Subject: VATTENFALL NORFOLK VANGUARD - Registration identification number: 20012656 Oulton Parish Council

Norfolk Vanguard

Oulton Parish Council's submission at Deadline 7

Appendix 1

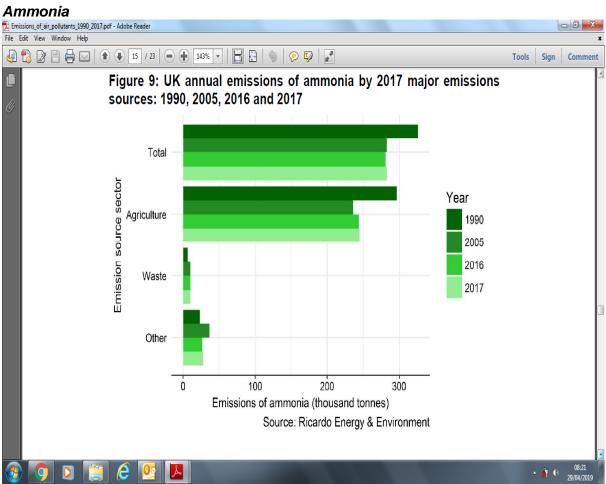
As an example, <u>agriculture</u> was responsible nationally for over 80% of ammonia emissions in 2017: has the applicant allowed for the existence *in the immediate vicinity of The Gatehouse* of a large intensive poultry farm and an outdoor and indoor pig rearing enterprise on the airfield? (**See Appendix 1**)

Appendix 2.

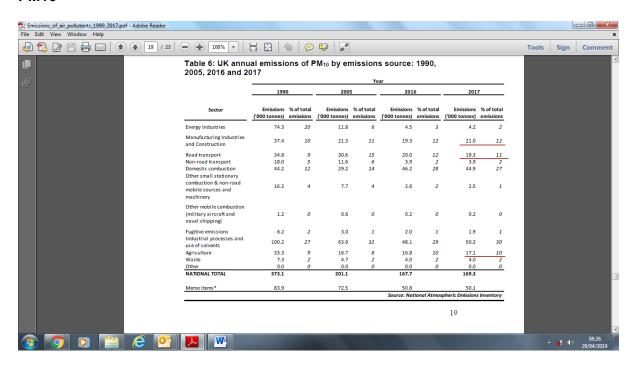
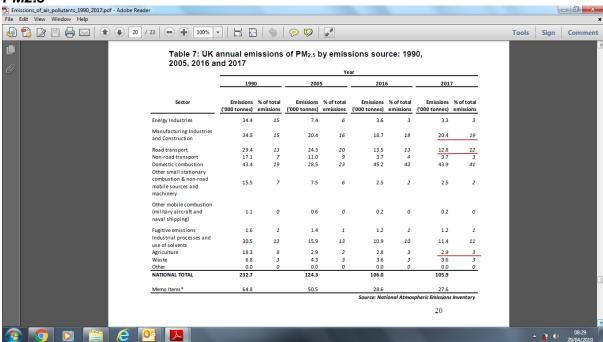
Furthermore, *all* agricultural vehicles run on diesel, with its dangerous emissions of PM 2.5. Has that fact been taken into account in the baseline data and added, along with the projects' cumulative impact of HGVs, in terms of air quality emissions? (**See Appendix 2**)
